SICK

Operating Instruction, Supplement ENGLISH

Supplement/deviation of technical data of the operating instructions MLG-2, 8023137:

Type: 1096760; MLG05A-0745B1M631 Lightgrid left

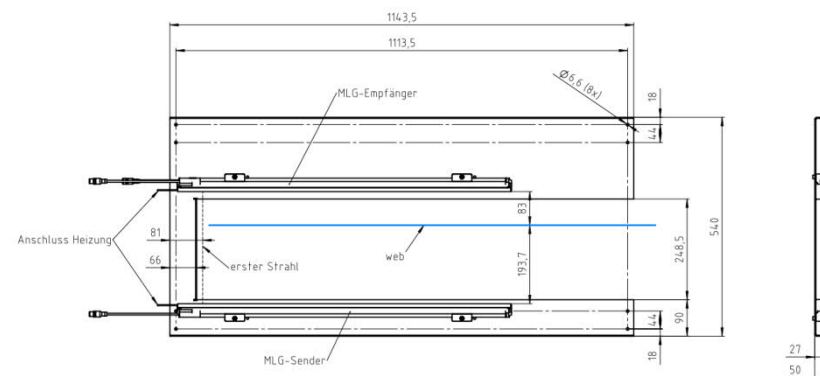
The heater has a resistance of 19.2 ohm.

To achieve 10W heating power, the heater can operate either with 13.9V constant voltage or 0.72A constant current.
